Groundwater Issues Associated with the Vickery Extension Project

Matthew Currell, Ph.D.
Associate Professor
School of Engineering
RMIT University
Melbourne VIC 3000
1st July 2020

Figure 1 Location of mapped high potential (dark green) and moderate potential (light green) GDEs – from Whitehaven, (2019). Grey shaded area indicates the Maules Creek Formation, in which groundwater drawdowns exceeding 100m are expected to occur.

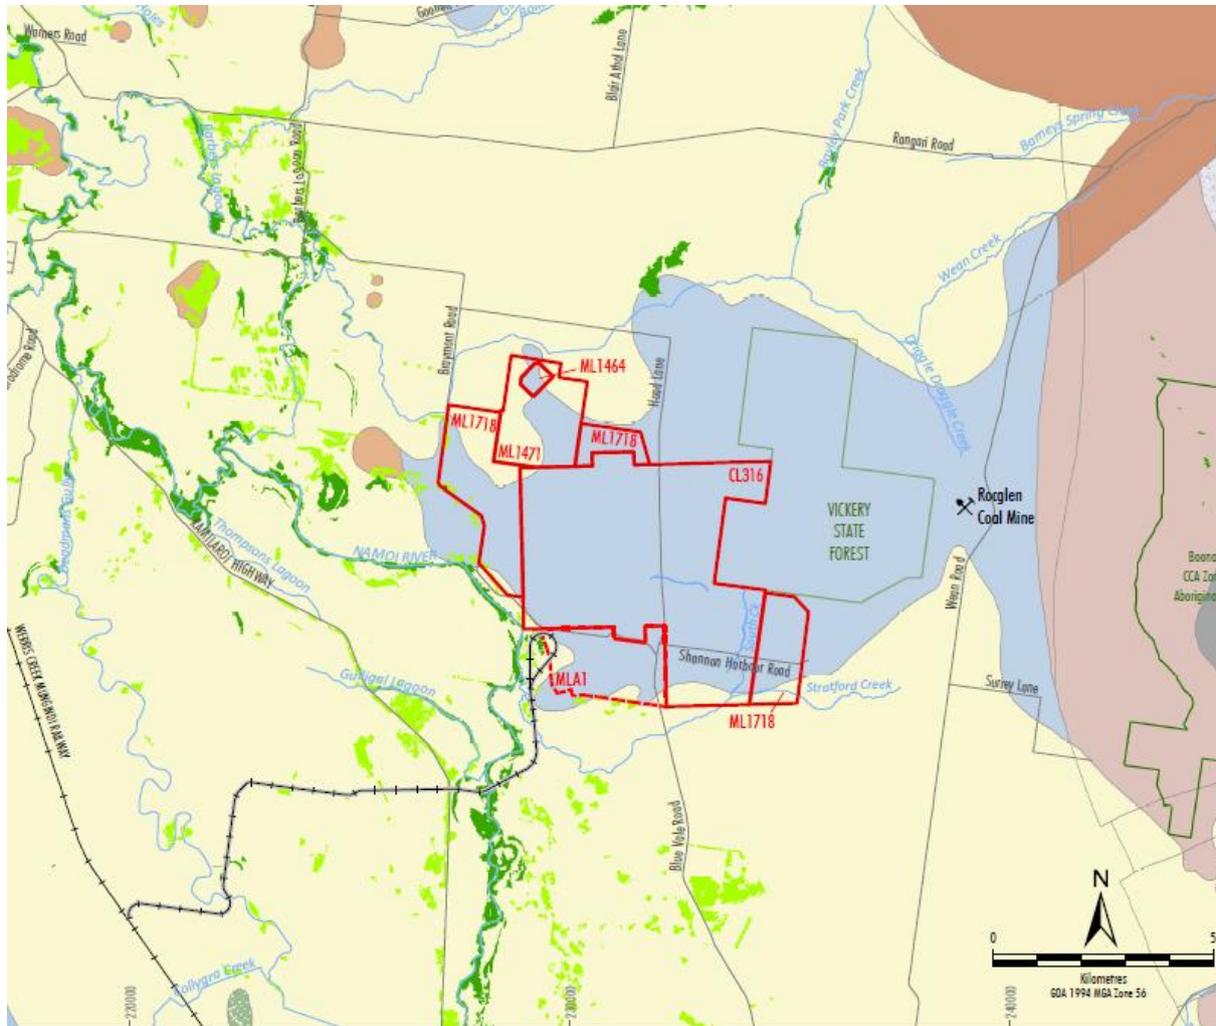
The proponent's Submissions Report included a new figure mapping potential GDEs within the project area (Whitehaven, 2019, figure 4 – reproduced as Figure 1 below). This only partly addresses the request from the IESC that the proponent produce:

The map produced (see below) includes the location of potential GDEs, based on the BOM’s National Atlas of GDEs. However, it does not show any contours of estimated depths to water table at different stages before or during mining or relevant bore locations (as requested by the IESC). While the peer reviewer (HydroGeoLogic, 2019a) believes the information provided is sufficient (as noted in the DPIE Assessment Report Table 7), the full scope of the original request of the IESC has not been fulfilled, and I believe it is important to see how water table patterns (and potentially, drawdown) are expected to develop in relation to the potential GDE locations as mining progresses.

The proponent argues in the Submissions Report that water table drawdown is not predicted to exceed 1m beyond the Maules Creek Formation (i.e., towards the Namoi River and its alluvium), which it implies to mean that such maps are superfluous. However, as discussed in further detail below, the assumption of limited drawdown is predicated on assumptions regarding inter-aquifer connectivity and aquifer hydraulic parameters which are yet to be sufficiently characterized at the site.

Irrespective of how much drawdown is predicted, the creation of these contour maps is important in order to assess potential changes to hydraulic gradients which may occur during the project, potentially impacting the rates of groundwater flow from the alluvium towards the open cut, or from the project area (e.g. western emplacement) towards the alluvium and river. Notably, there are places where the Maules Creek Formation (in which significant drawdown is predicted to occur) is immediately adjacent to the Namoi River and as such water table levels in this unit during mining must also be considered in any GDE risk assessment (as is recommended to be conducted by the IESC, according to the methods of Serov, 2012).

surface water (e.g. through increasing the hydraulic gradients and leakage rates from the Namoi and its alluvium towards the open cut). The project's proposed open cut boundary comes close to the Namoi River – within approximately 2 km - where both moderate and high potential GDEs have been mapped using the BOM's Groundwater Dependent Ecosystem Atlas (see Figure 4 of the Submissions Report, reproduced below):

According to the map from the Submission Report reproduced above (Fig 1) there are areas where the Maules Creek Formation appears to be directly adjacent to the Namoi River (as well as areas where the river is flanked by extensive alluvium), and there is a high potential for GDEs to occur along the stream length. As such understanding effects of water level changes on near-stream hydraulic gradients both within the Namoi Alluvium and the Maules Creek formation, under current conditions

Figure 2 – Conceptual groundwater flow model at peak of mining (reproduced from HydroSimulations, 2018 in the project EIS).

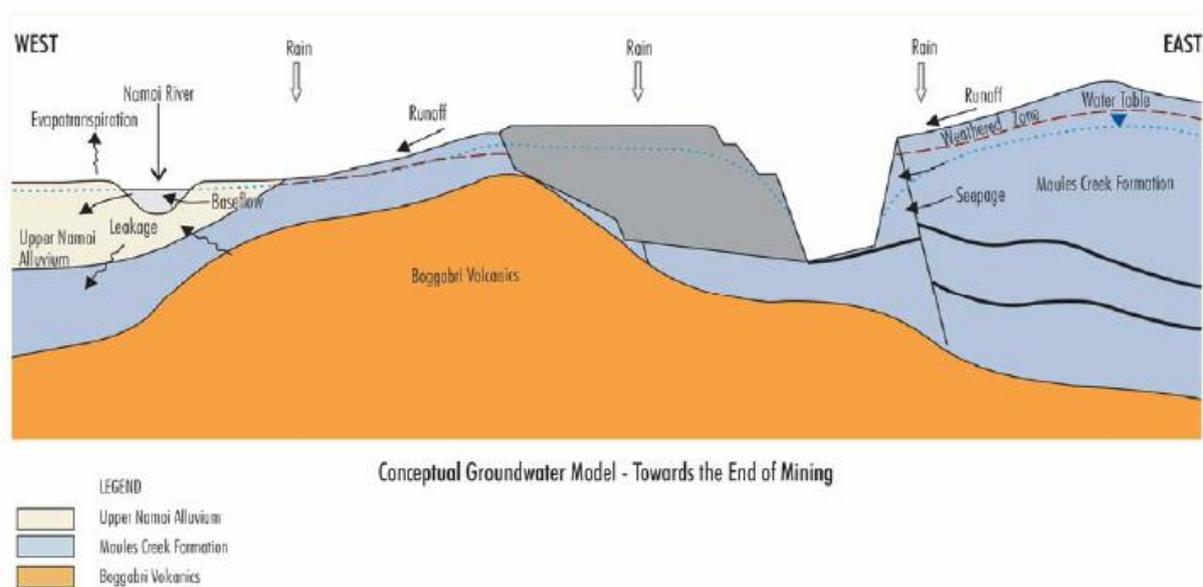
The potential for water quality impacts resulting from the placement of mine waste on the Namoi Alluvium, at an embayment of the river in the northwest of the project area, was highlighted as a potential concern by DPIE Water. It is estimated the area covered would be approximately 200 ha. The hydrogeology peer reviewer also commented on this issue. The concern is that leaching of metals and other potentially harmful elements in the overburden could occur, recharging the underlying groundwater and therefore impacting water quality within the Namoi Alluvium. HydroGeoLogic (2020) expressed a view that due to long term development of ‘sink’ conditions in the mine void, any poor quality water recharging the alluvium will ultimately discharge back into the mine void (being within the void’s ‘capture zone’). In my view this is still not comprehensively demonstrated. If the conceptual model outlined in Figure 33 of the groundwater assessment (reproduced below) is correct, it is assumed there will continue to be a groundwater divide between the Namoi River and mine pit at the peak of mining. This would mean there could be a potential flow-path towards the alluvial aquifer and river, from the area of emplaced overburden. It is not fully demonstrated in the figures provided (e.g. Hydrogeologic 2020; Whitehaven, 2019) that all flow would indeed be captured by the mine void (as specific flow paths are not mapped). Due to the inherent uncertainty in groundwater modelling of this type, it is reasonable to conclude that the specific water table patterns that develop in the later stages of mining may vary from the predicted pattern. This may include the development of water table mounding below the emplaced mine overburden, with some flow directed back towards the alluvium, rather than towards the mine void.
